Access Compliance Report

Public Rights-of-Way

(Pedestrian Signals)

Intersection ID: N/A	Main Street:	Cross Street: N/A	Location: N/A
ADA ID: C008DE994DAD	Signal Type: One Push Button-APS	Overall Compliance: No	Severity Score: BTN 1: N/A BTN 2: N/A No BTN: N/A
Codes/Mitigation Info/Possible Solution		Field Measurements/Component Compliance

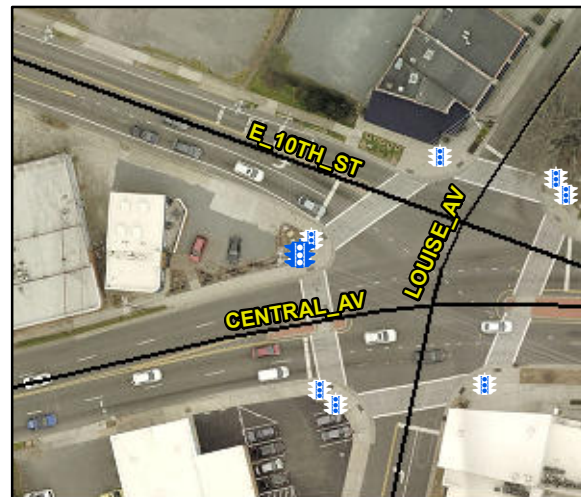
Surveyor Notes: TEXT HT 3/8, WORDING ON SIGN ILLEGIBLE

PROW/ADA: , TMUTCD 4e.08, R410.6, R209.1, R404.1, R406.2, R404.7.3

Possible Solutions: Replace Signal Push Button With APS Button on New Post. Remove & Replace Sign.
